NLE and NLV Compressors Angle of Suction Connector Change

In order to standardize the connector setup, we will be changing the angle of the suction connector for the NLE (NLV) compressor line.

Fig. 1 Suction connector with 45° angle

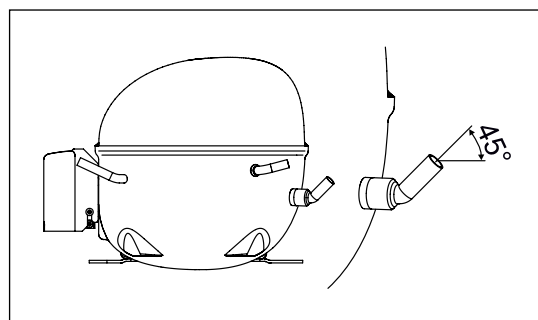
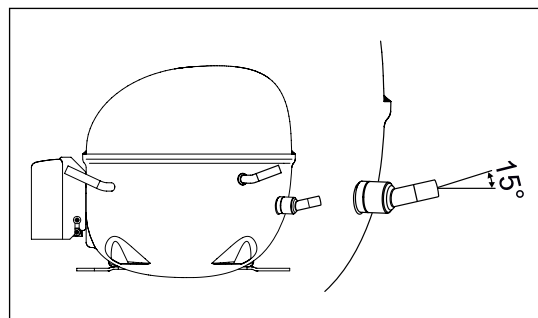
Currently, the angle is 45° (see figure 1). In the future, it will be reduced to 15° (see figure 2). In addition, the connector will be shortened by 3 mm.
